## **BID ADDENDUM NO. 6**

### **Johnson Student Center**

### **Building Demolition, Increment 1 (Demolition) and Increment 2**

RANCHO SANTIAGO COMMUNITY COLLEGE DISTRICT  
SANTA ANA, CA

SHEET NUMBER  
**C1.0-D**

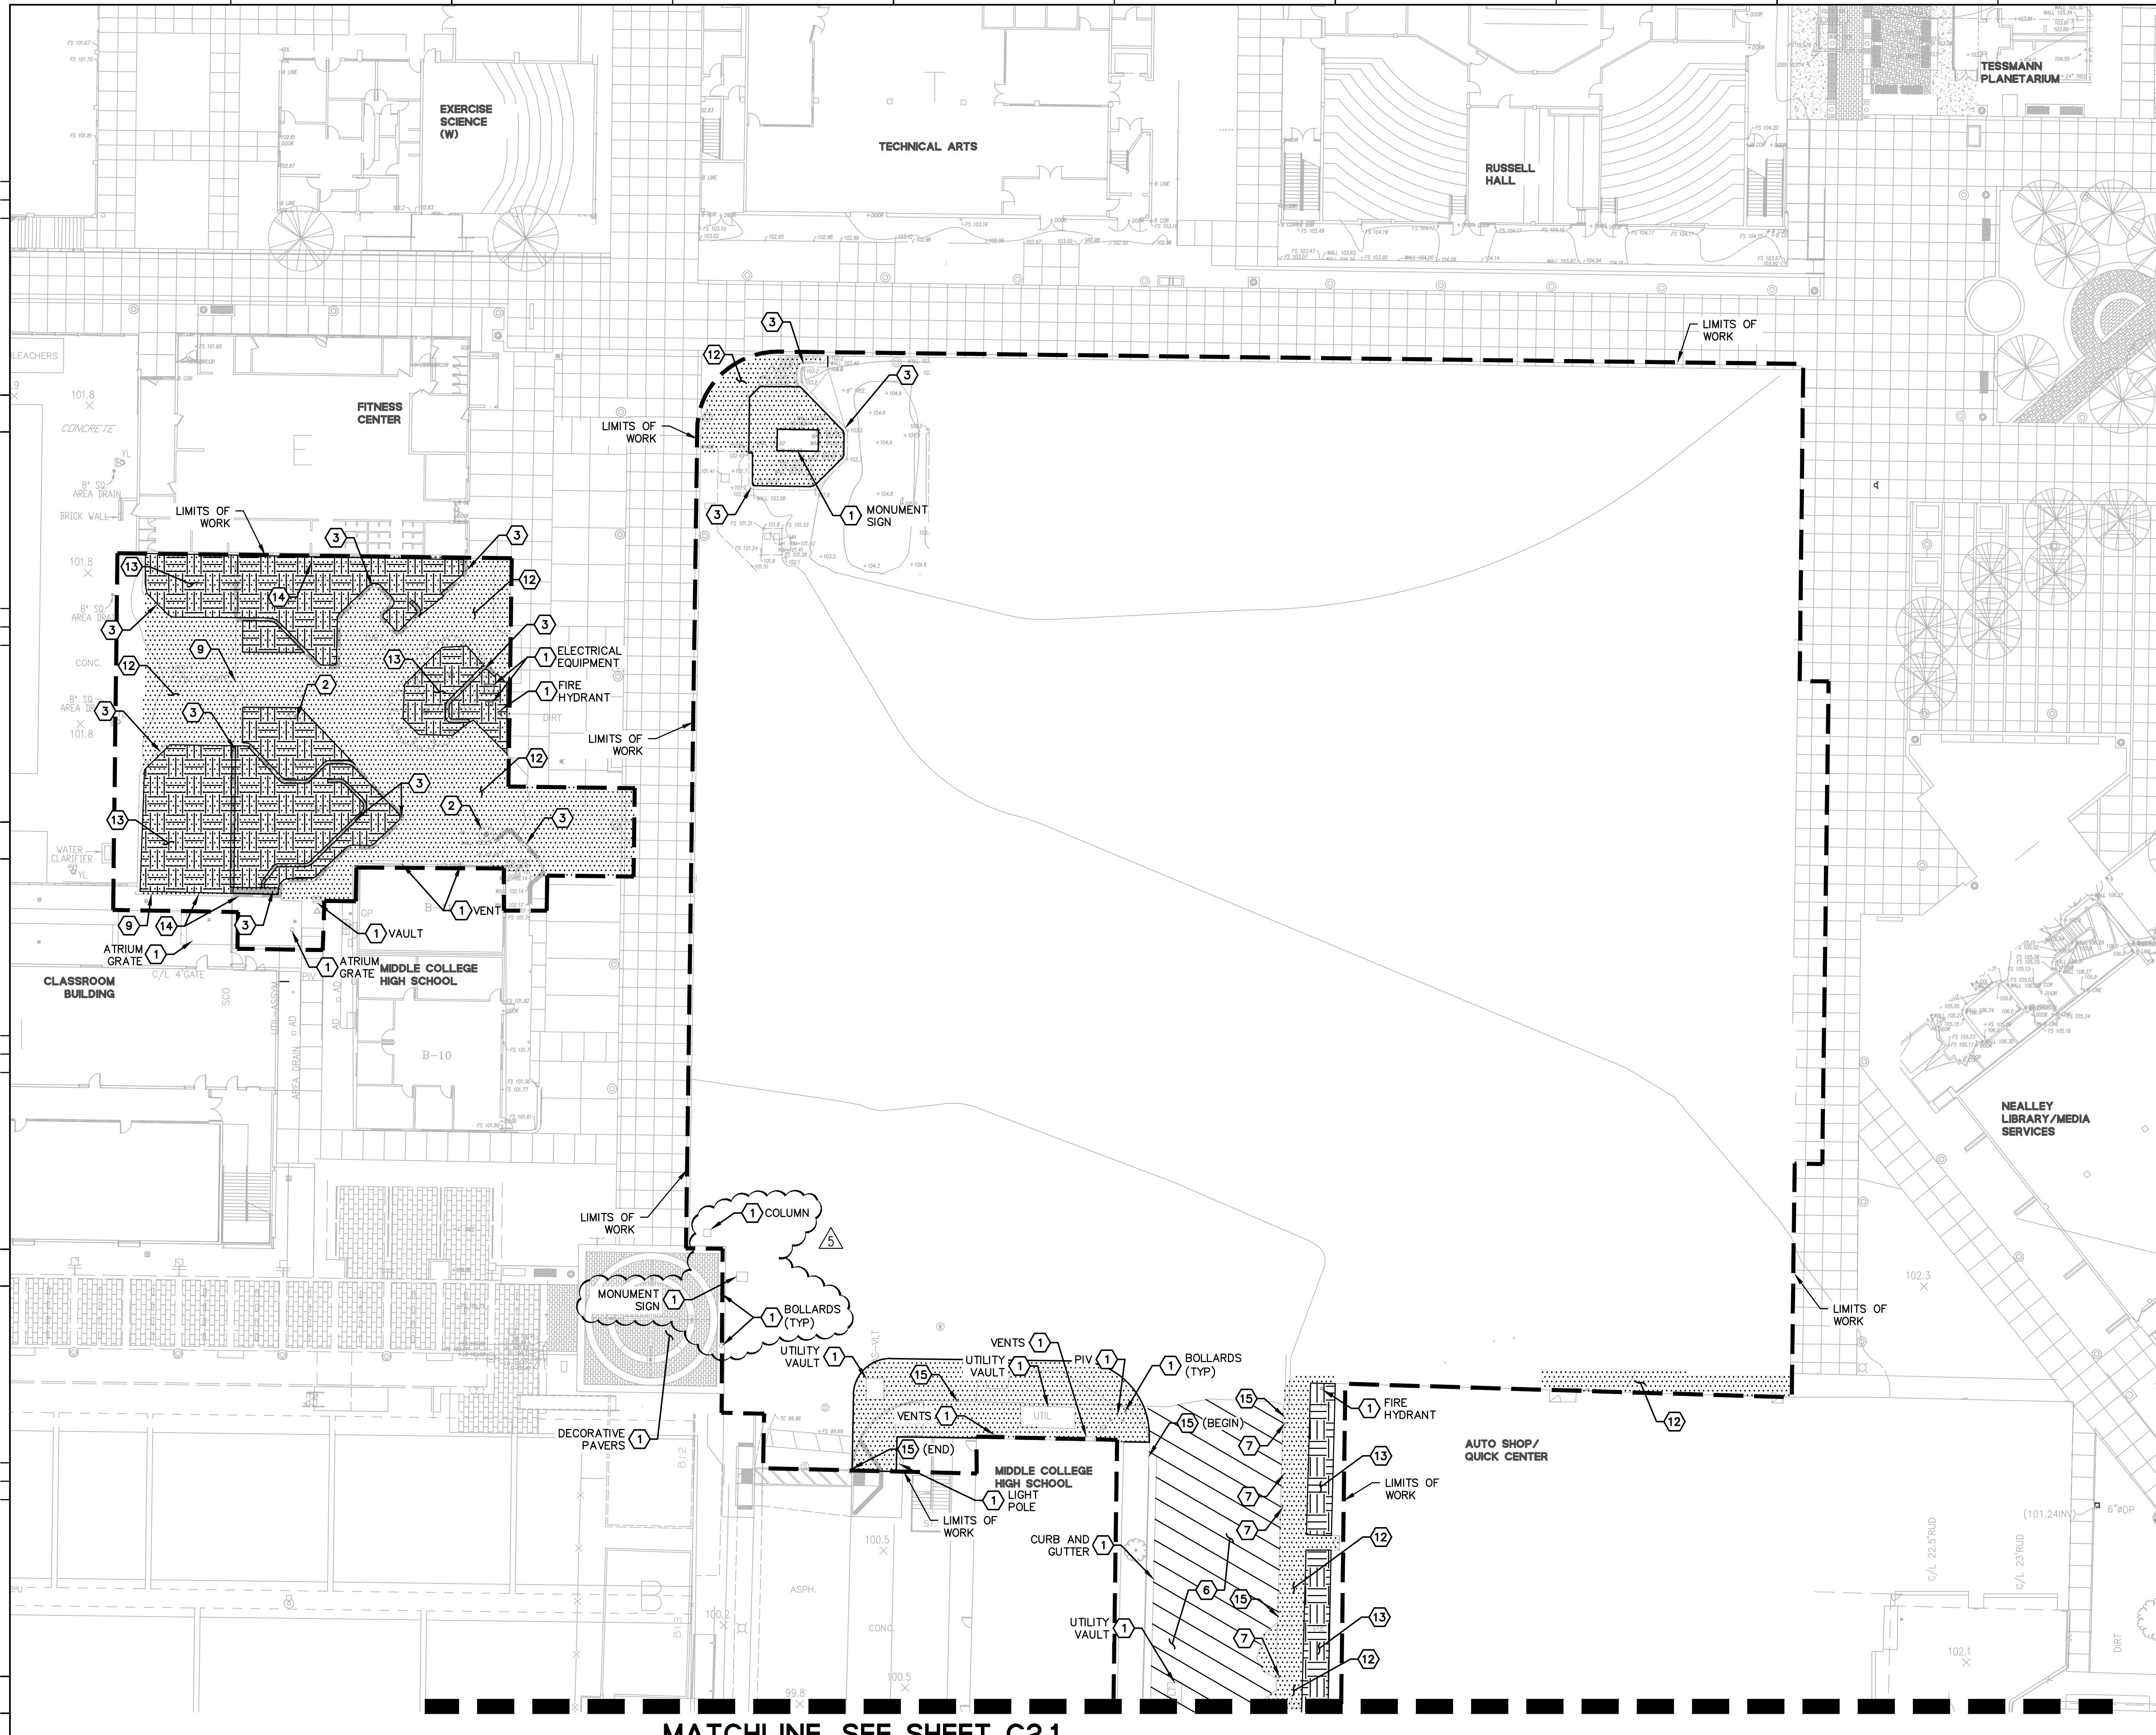
- Increment #1: Revised sheet C1.0-D southwest corner to show existing site signage and bollards to be protected in place.
- Increment #1: Revised depths of cap/pile removals from 8' to 10'.
- Increment #2: Revised sheet C2.0 southwest corner to show existing site signage and bollards to be protected in place.

**M2.01**

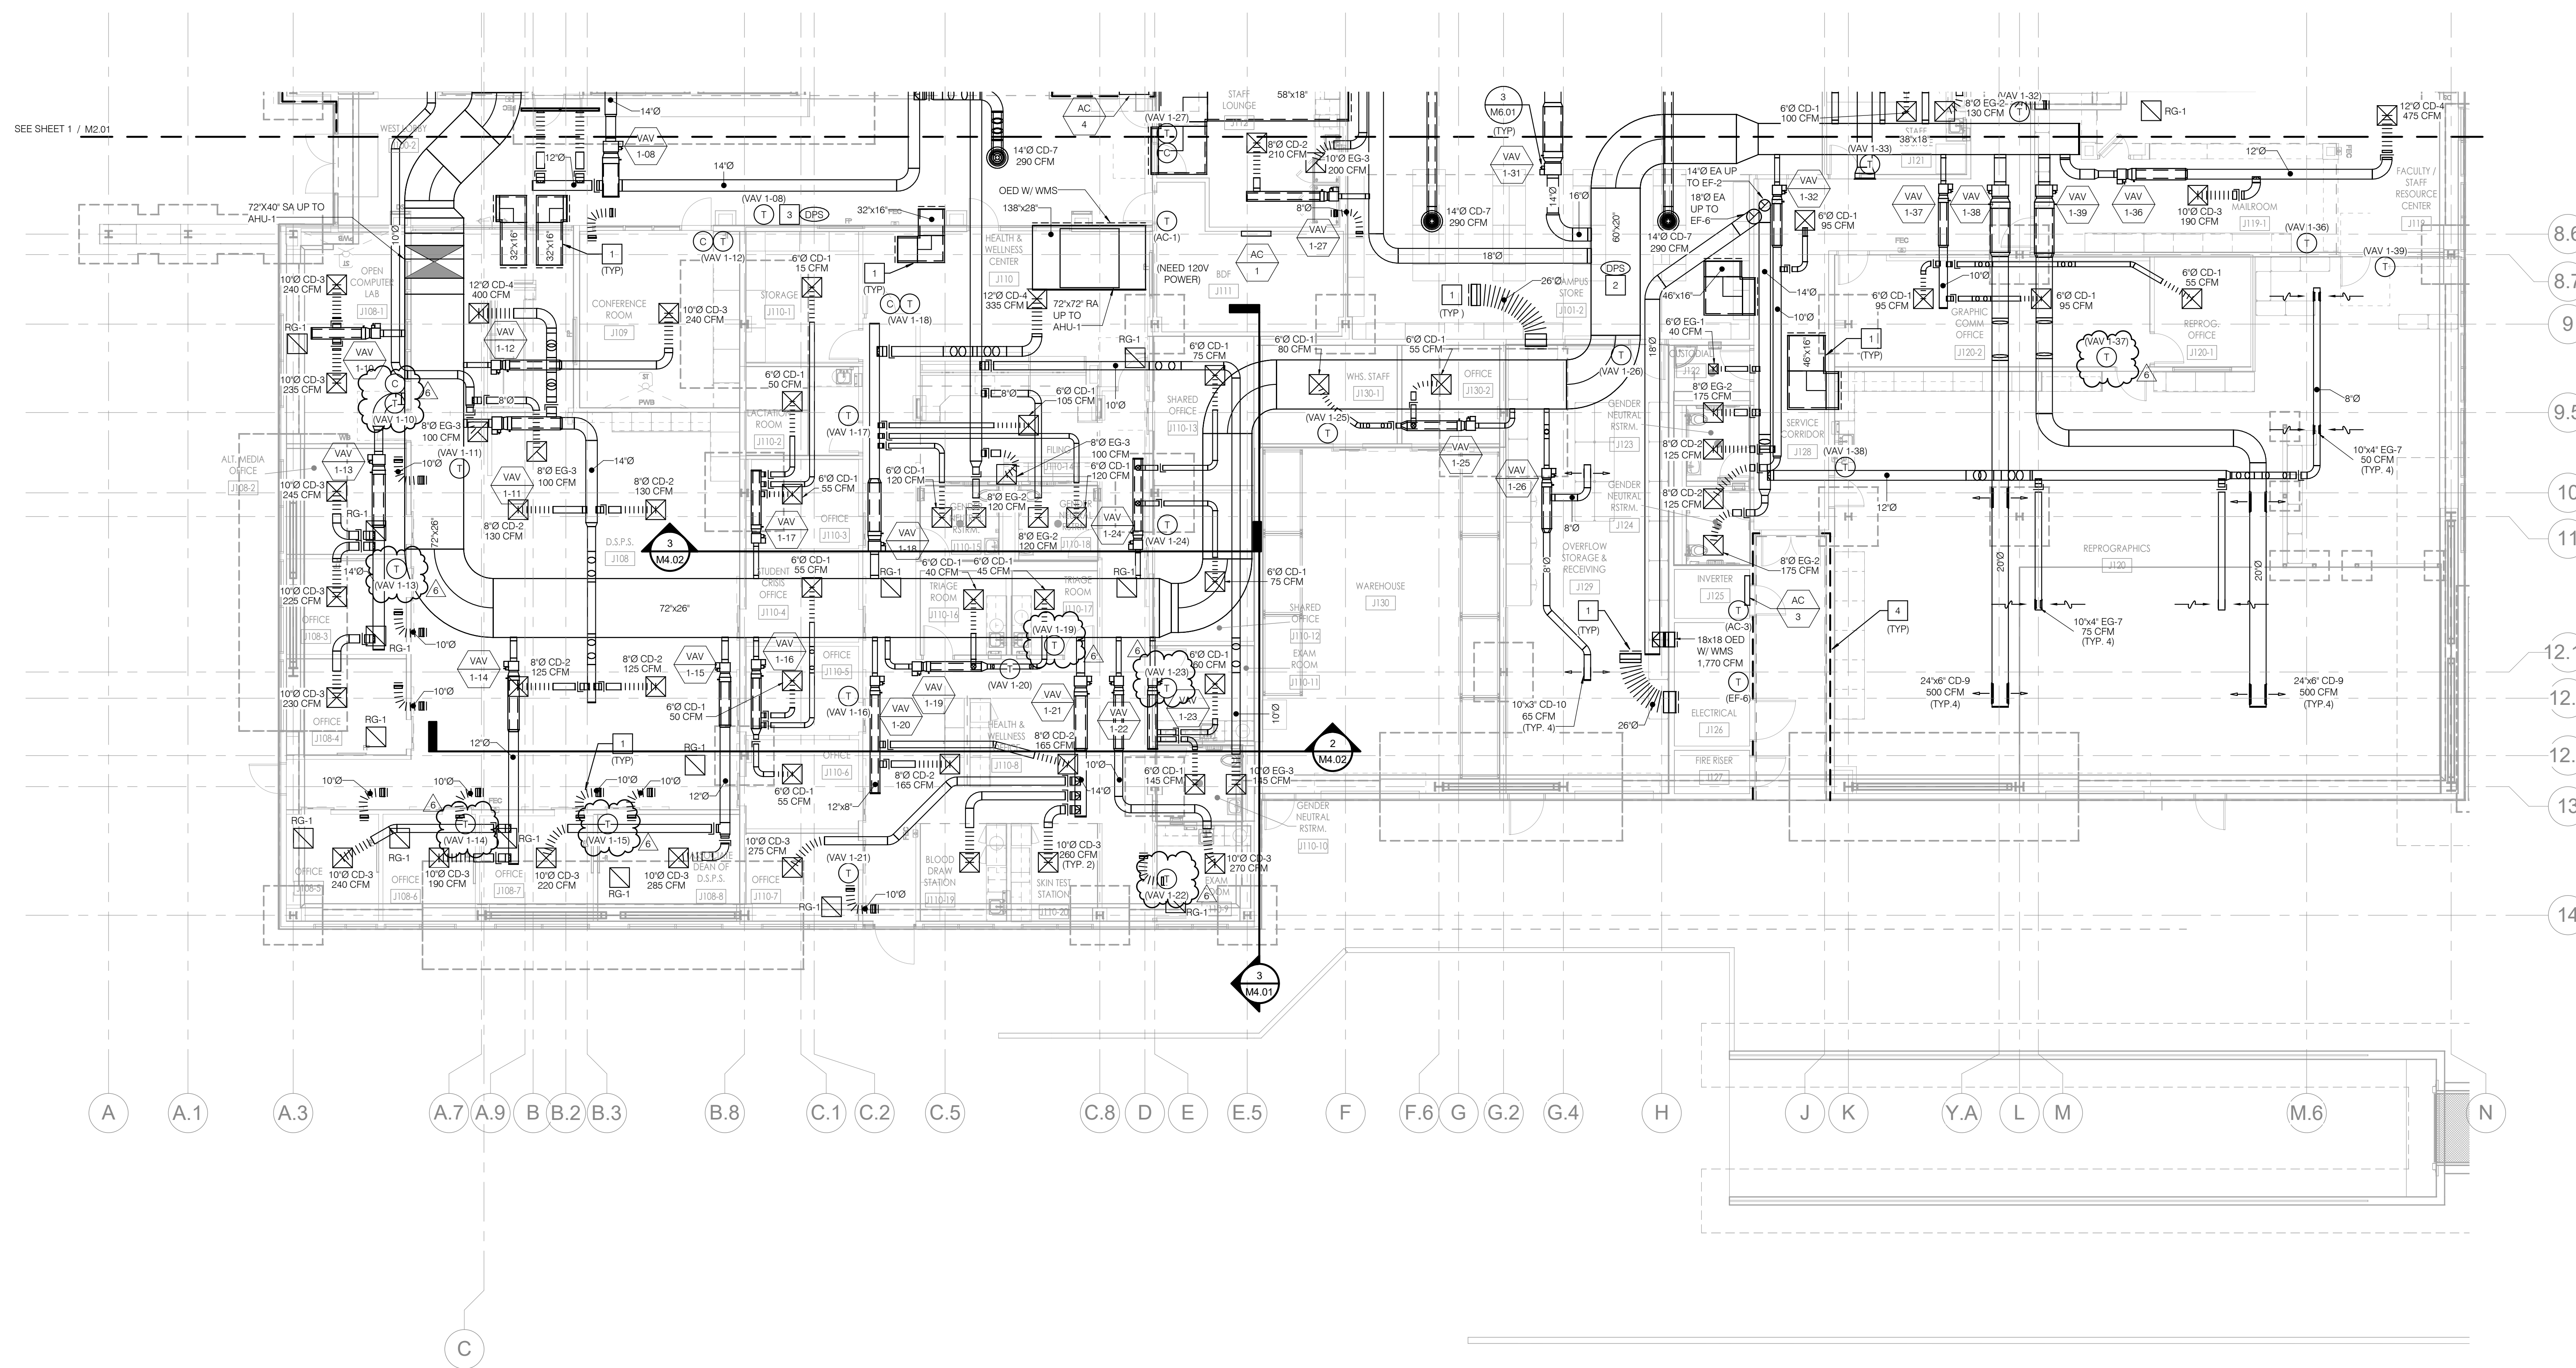
- Increment #2: Revised locations of Thermostats due to conflicts with wall mounted equipment/accessories, refer to sheets M2.01, M2.02, M2.03 and M2.04. Clouded and deltaed. Trades to coordinate so that wall mounted switches/devices/accessories to not conflict with markerboard, tackboards, access panels, furniture, etc. it shall be brought to the attention of the design team prior to commencing work if there is a conflict so that direction can be given.

**EXHIBIT A**

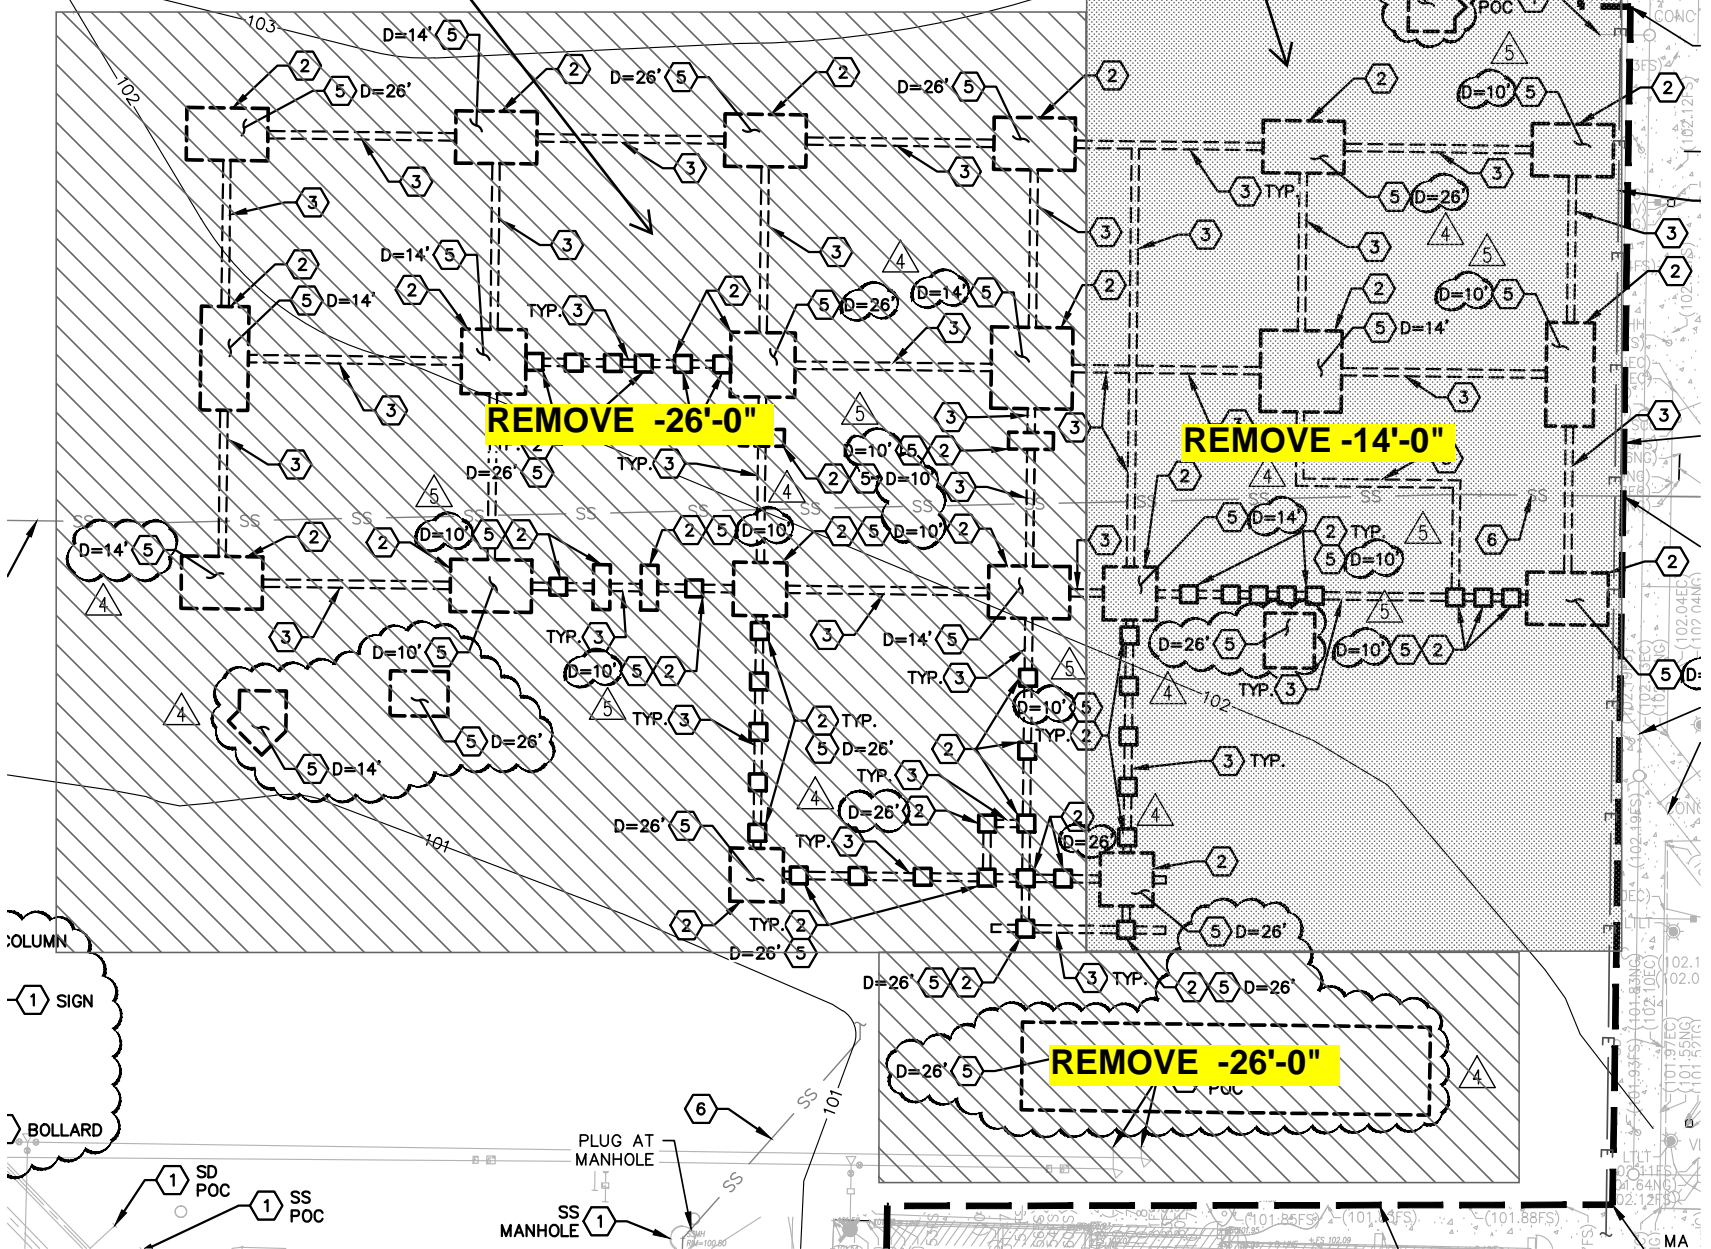
- Increment #1: ALTERNATE NO. 6 - Pile Demolition depth; Refer to attached Exhibit A for the existing pile demolition/removal depths.
- Increment #2: General note: Where there is conflict/overlapping with restroom accessories with access panels, move the access panel up/above the accessory. Be consistent with vertical heights.

REFERENCE TO REMOVE ENTIRE SOG, FOUNDATION, FOOTINGS, CAPS AND PILES TO A DEPTH OF -14'-0" WITHIN THIS ZONE.

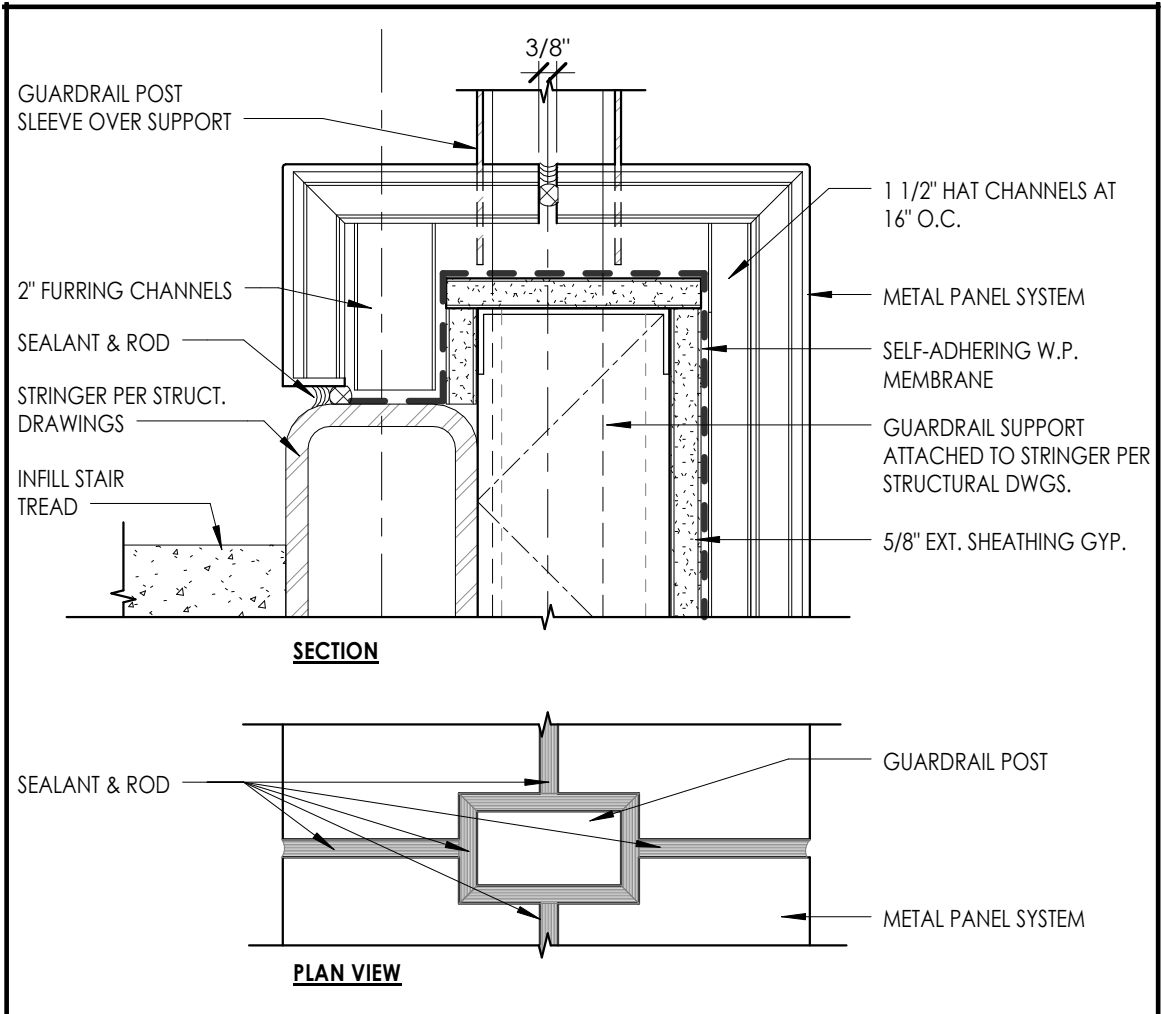
Increment #2 - Detail 5/A9.72 - The metal panel cladding around the Stair guardrail shows the waterproofing wrapping up the guardrail support and the metal panel comes up to the support, however there is nothing stopping water from getting behind the metal panel. Please review and advise. Should sealant be added to this detail?

**REFER TO ATTACHED FOR REVISED DETAIL 5/A9.72  
WATERPROOFING AROUND GUARDRAIL IS NOT NEEDED. SEALANT AND ROD  
SHOULD BE ADDED AROUND THE POST AND BETWEEN THE METAL PANELS.  
PLAN VIEW IS ALSO PROVIDED IN THE SAME DETAIL.**
